Development Review Committee

1. Discussion: **Mission Rise Development PUD Rezoning Submittal**

MEMORANDUM

TO: Howey-in-the-Hills Development Review Committee
CC: J. Brock, Town Clerk
FROM: Thomas Harowski, AICP, Planning Consultant
SUBJECT: Mission Rise Development August 2023 Resubmittal
DATE: September 6, 2023

DEVELOPMENT SUMMARY

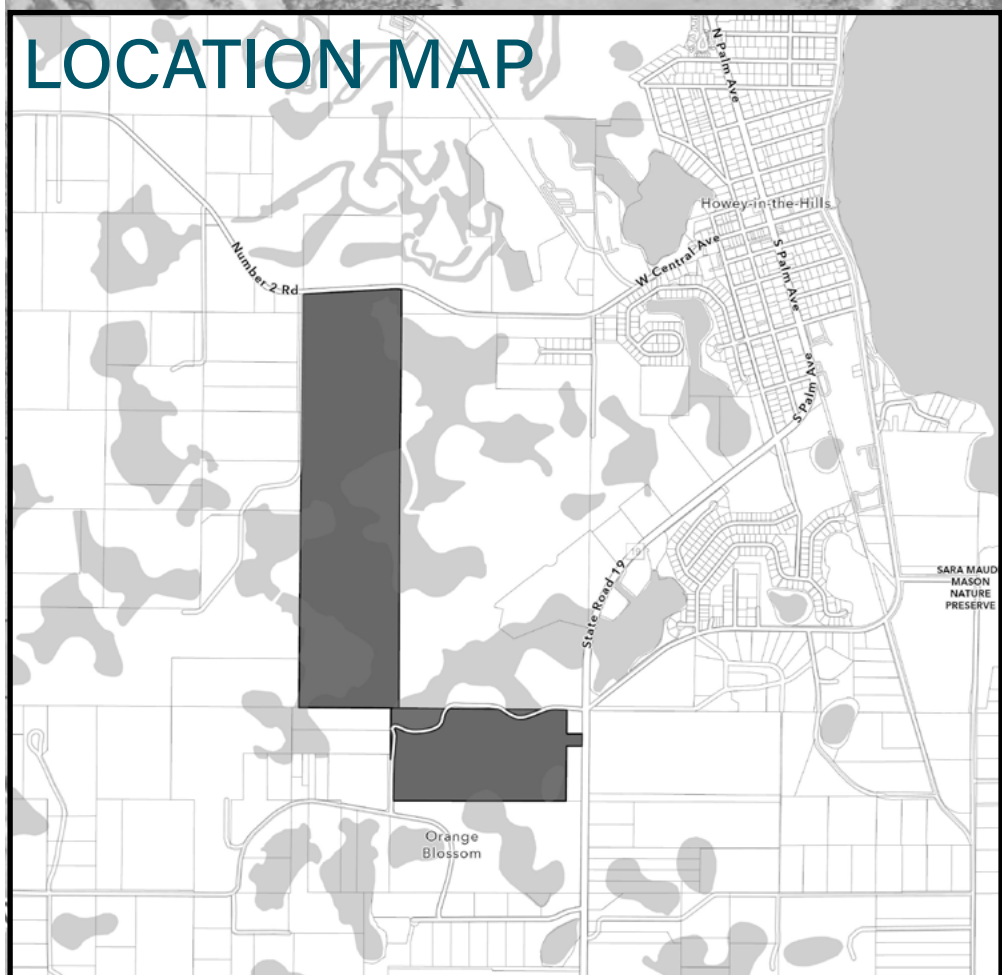
8. The unit totals provided for the phase allocations do not add correctly on the table provided.
9. The note to the table needs to be removed. Movement of units between phases will be considered a major amendment of the development agreement. As an alternative the applicant could propose language in the development agreement allowing for a specific level of shifting units between phases for Town Council consideration.

1. The conceptual land use plan states the maximum number of lots is 499. The traffic study and the development agreement states 592 lots. All three need to be the same.

Please see Sheet 2 for a tabulation of the proposed number of units by lot size for each phase of the proposed PUD. Please note that the proposed phasing and allocation of units by phase is approximated, and subject to change during the subdivision plan stage. A note to this effect has been added to Sheet 2 of the Conceptual Land Use Plan.

PARKS & TRAILS PROGRAM

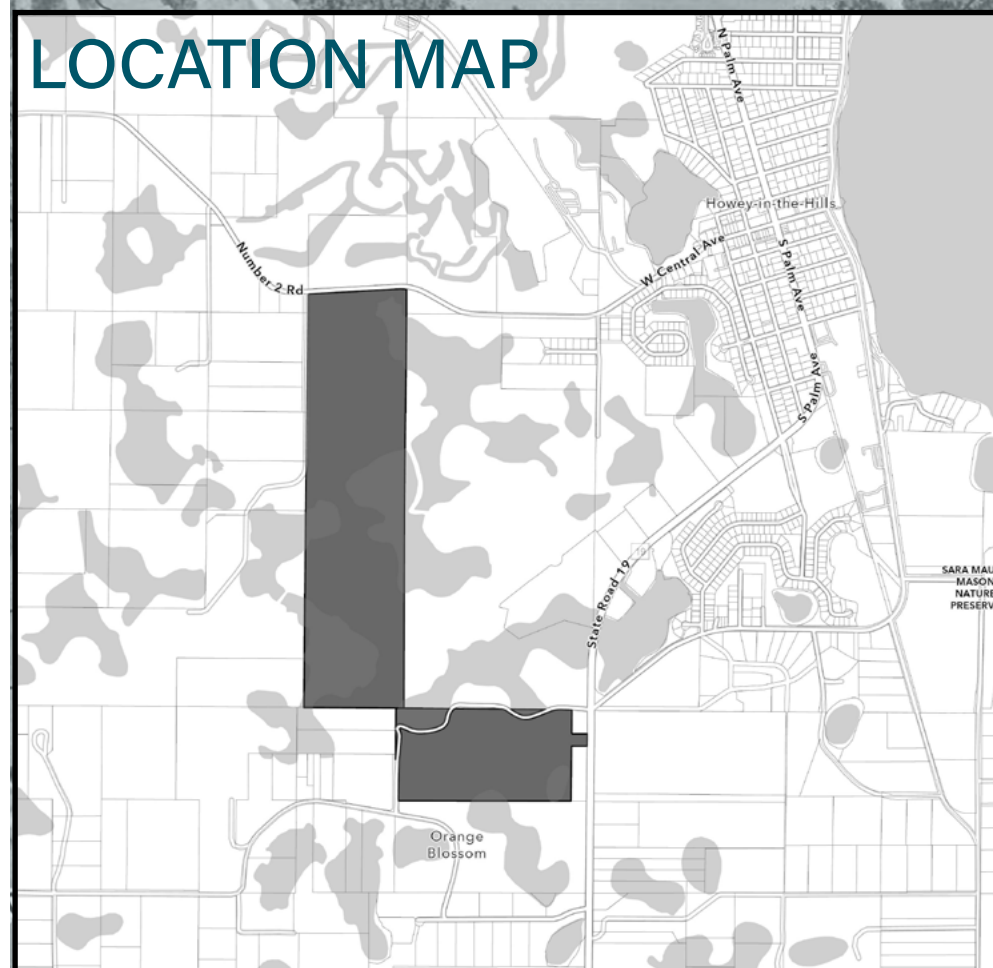
2. The proposed recreational facilities have been better detailed, but the “regional” park still fails to meet the definition included in the comprehensive plan. Perhaps revising the name to a neighborhood facility is more appropriate given that the park is unlikely to draw significant interest from residents outside the neighborhood.

RESPONSE: The multiuse trail and park system is proposed to meet the project's non-residential land area requirement. Please see Sheet 3 of the Conceptual Land Use Plan for further detail.

RESPONSE: Acknowledged. Further detail on the multiuse trail and park system has been provided on Sheet 3.

SPINE ROAD
90' ROW WITH BIKE LANE & 12' MULTIMODAL TRAIL

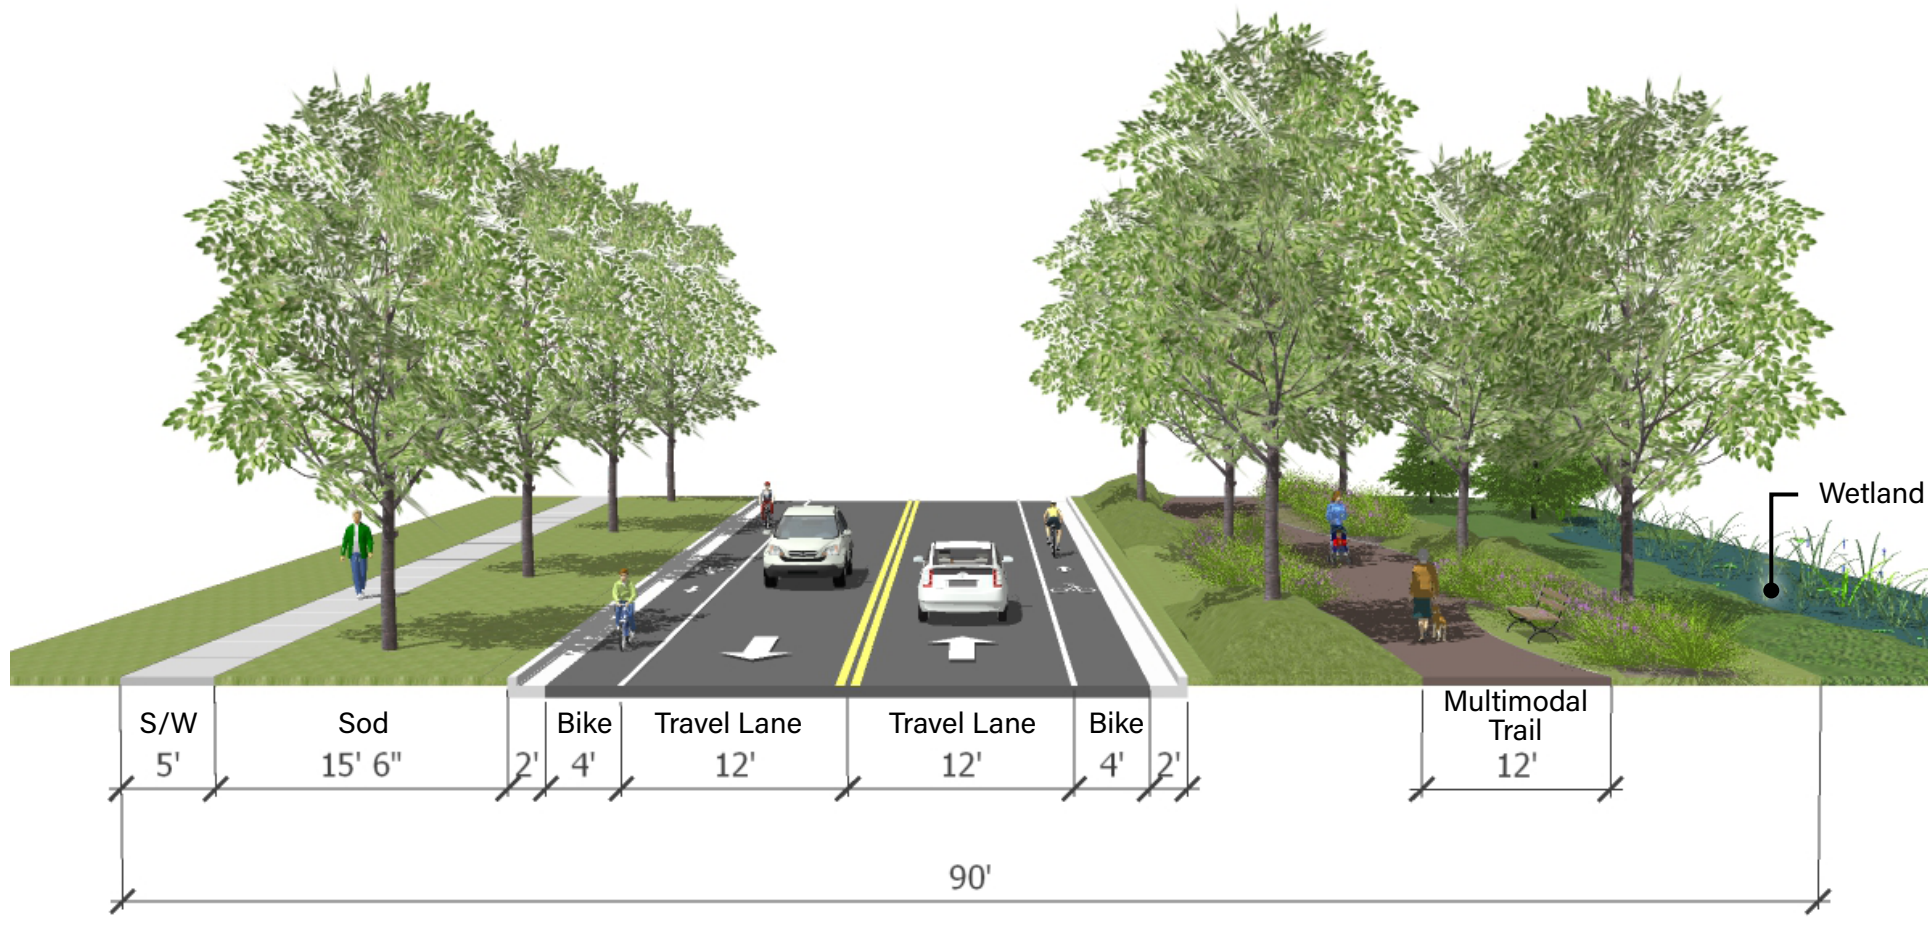
2. The plan could take better advantage of the terrain by locating the multi-use trail outside of the collector road right-of-way when possible. This placement will open ROW the door for consideration of the trail as a component of the non-residential area requirement.

5. The design of the major collector needs to plan for a median and turn lanes at intersections. The two cross-section provided do not include a landscaped median area. Where properties have direct access from the collector road, periodic openings can be provided

RESPONSE: The multiuse trail design has been updated to locate the trail outside of the Collector Road ROW.

RESPONSE: As discussed at the DRC meeting on August 10, 2023, the Collector Road cross-section is proposed without a median, but will include 4' bike lanes as well as a 12' multi-use trail.

RESPONSE: Acknowledged, the revised Conceptual Land Use Plan proposes Option 1 for the Collector Roadway design. This has further been updated to increase the width of the multiuse trail to 12'.
